SUBJECT: Calvert Cliffs Nuclear Power Plant  
Unit No. 1; Docket No. 50-317  
Partial Withdrawal of Proposed Technical  
Specification 3.1.1.1, Unit 1, (TAC NO. 67143)

Specifically, all changes proposed for page 3/4 1-1 of Technical Specification 3.1.1.1, should be withdrawn, except the reference to Figure 3.1-1b. The withdrawal of these proposed changes replaces applicability of Technical Specification 3.1.1.1 to the critical Modes of operation. By this withdrawal, the page number for Figure 3.1-1b will change from the proposed 3/4 1-2 to 3/4 1-2a.

Figure 3.1-1b

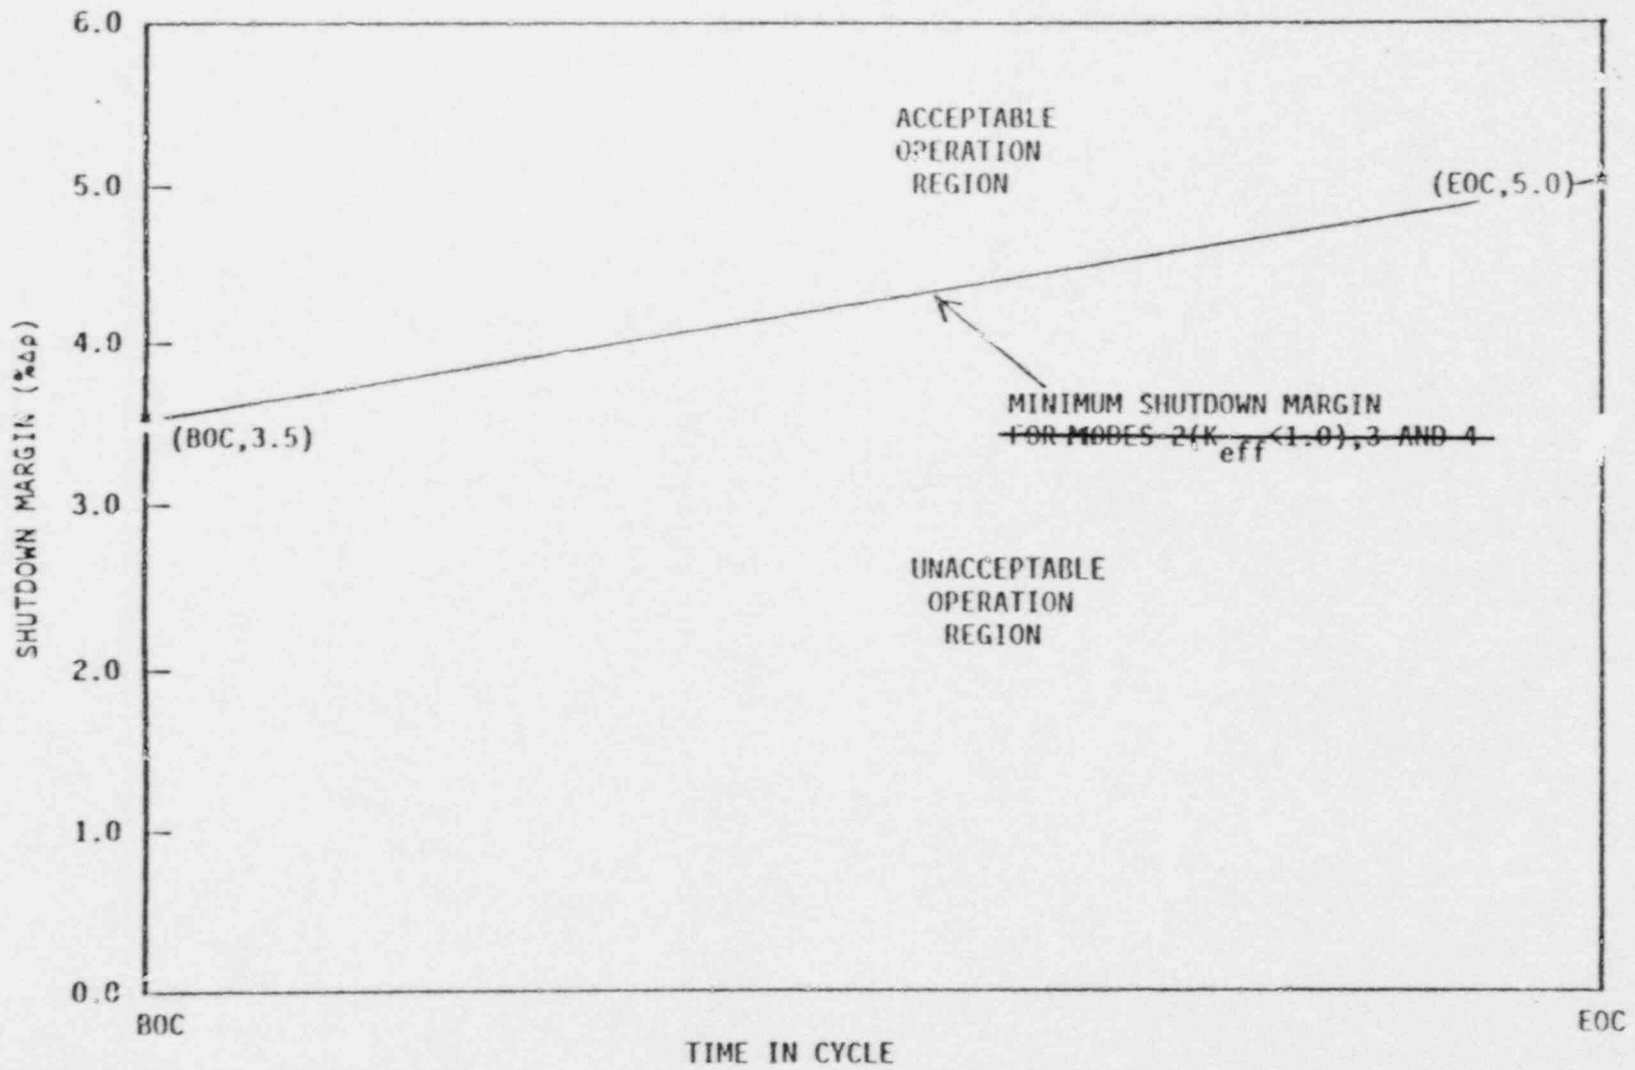
3.1.1.1 The SHUTDOWN MARGIN shall be  ~~$\geq 3.5\% \Delta k/k$~~  <sup>equal to or greater than the limit line of Figure 3.1-1b.</sup>

<sup>less than the limit line of Figure 3.1-1b,</sup>  
With the SHUTDOWN MARGIN  ~~$\leftarrow 3.5\% \Delta k/k$~~ , immediately initiate and continue boration at  $\geq 40$  gpm of 2300 ppm boric acid solution or equivalent until the required SHUTDOWN MARGIN is restored.

4.1.1.1.1 The SHUTDOWN MARGIN shall be determined to be  ~~$\geq 3.5\% \Delta k/k$~~  <sup>equal to or greater than the limit line of Figure 3.1-1b;</sup>
